STAFF REPORT
COMMUNITY DEVELOPMENT DEPARTMENT

SUBJECT: FP-2021-0001
Delano No. 1

Final plat consisting of 60 buildable lots and 9 common lots on 10.45 acres of land in the R-8, R-15 and R-40 zoning districts for the first phase of Delano Subdivision.

B. Final Plat (dated: 12/12/20)

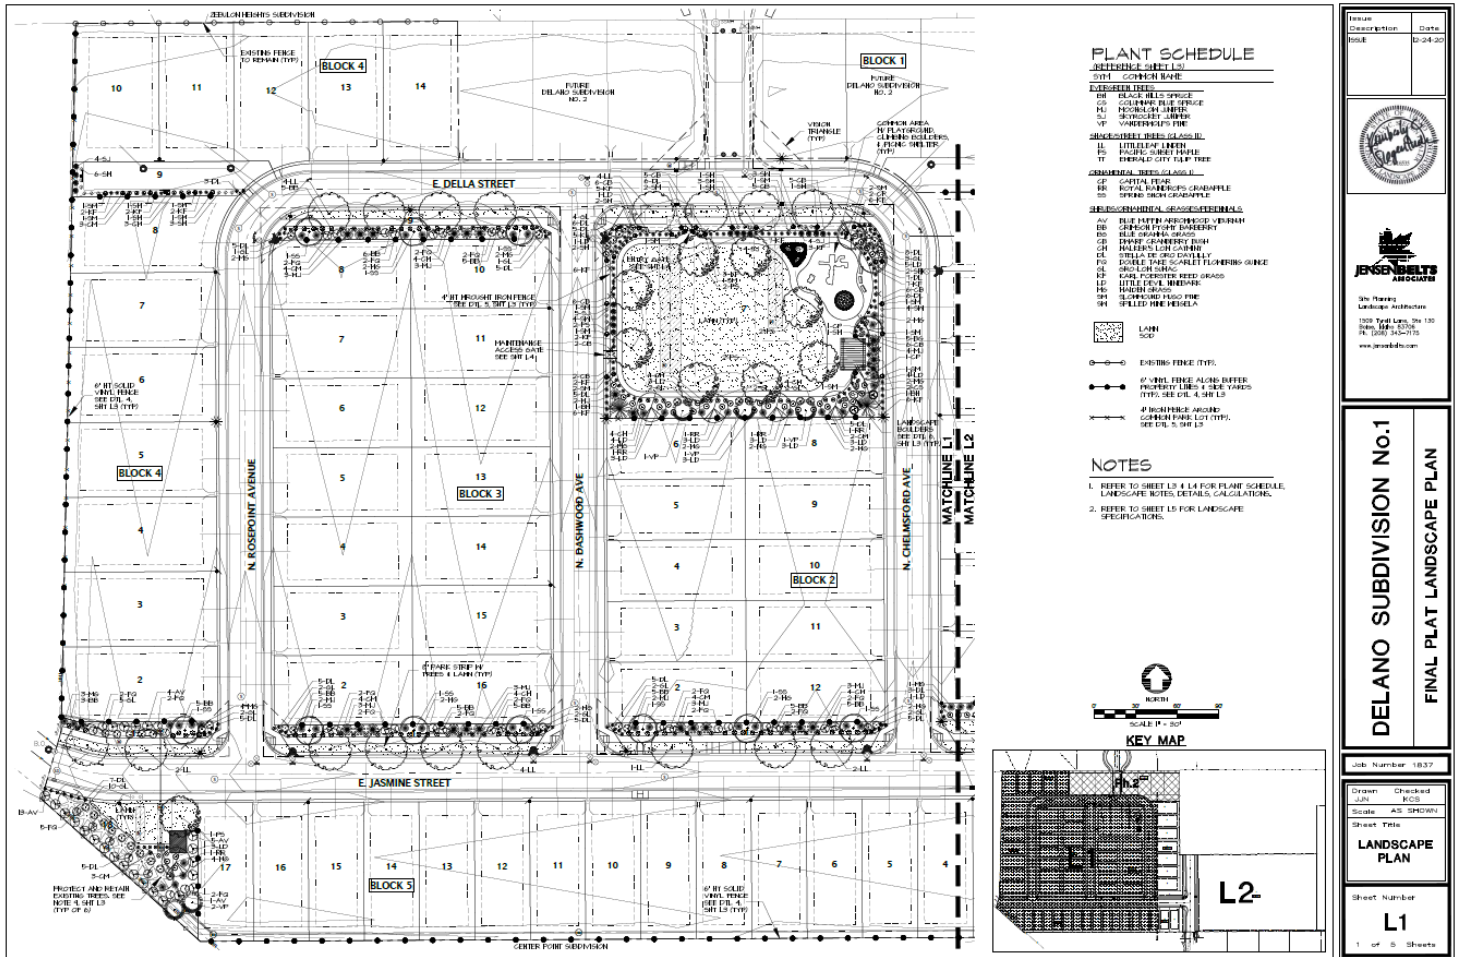
1. Applicant shall comply with all previous conditions of approval associated with this development (H-2019-0027; Development Agreement Instrument Number 2020-131190).
2. The applicant shall obtain the City Engineer's signature on the subject final plat within two years of the City Council's approval of the preliminary plat (on or before August 11, 2022); or apply for a time extension, in accord with UDC 11-6B-7.
3. Prior to submittal for the City Engineer's signature, have the Certificate of Owners and the accompanying acknowledgement signed and notarized.
4. The final plat prepared by Sawtooth Land Surveying, LLC stamped by Jeff Beagley, dated: 1/5/2021, included in Section V.B shall be revised as follows:

Plat Notes:

- a. Plat Note #4: ~~"... Meridian City Code unless otherwise modified by conditional use permit."~~
- b. Plat Note #7: Include the ACHD License Agreement recorded instrument number.
- c. Plat Note #11: Include ACHD sidewalk easement recorded instrument number.
- d. Plat Note #12: Remove note as it's not applicable.

Legend:

- e. Include the recorded instrument number of the 30' water/sewer easement.

Face of the plat:

- f. Depict the common lot line for Lots 1 and 7, Block 2.
- g. Depict the street buffer on Lot 1, Block 6 in a minimum 20-foot wide common lot as set forth in UDC 11-3B-7C.2a; and include lot and block number in Note #6.
- h. Depict the Block number (i.e. Block 1) on Sheet 1.
- i. Include the Phase # (i.e. 1) in the subdivision name.
- j. Depict the location of the cross-access/ingress-egress easement on Lot 1, Block 6 to the east to Parcel #R4582530202 required in condition #12 below.

A copy of the revised plat shall be submitted with the final plat for City Engineer signature.

C. Landscape Plan (dated: 12/24/2020) & Amenity Details

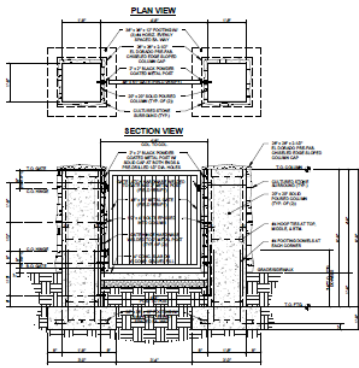
5. The landscape plan prepared by Jensen Belts Associates, dated 12/24/2020, included in Section V.C, shall be revised as follows:
 - a. Depict the location of the proposed swing set on Lot 7, Block 2 and public art on Lot 18, Block 5 on the plan.
 - b. Widen the street buffer along the east side of N. Centrepoint Way to a minimum of 20-feet and depict landscaping in the entire street buffer in accord with the standards listed in UDC 11-3B-7C.3. Depict trees and shrubs in the street buffer along the east side of N. Centrepoint Way. Depict the street buffer in a common lot as required in condition #4.g above.
 - c. Correct the street names consistent with that shown on the plat (i.e. E. Della St. should be W. Eagle View St.; N. Rosepoint Ave. should be N. Amberwood Ave.; and N. Centerpoint Way should be N. Centrepoint Way).

- d. Include the linear feet of parkways and the required vs. proposed number of trees in the Landscape Calculations table demonstrating compliance with the standards in UDC 11-3A-17 and 11-3B-7C.
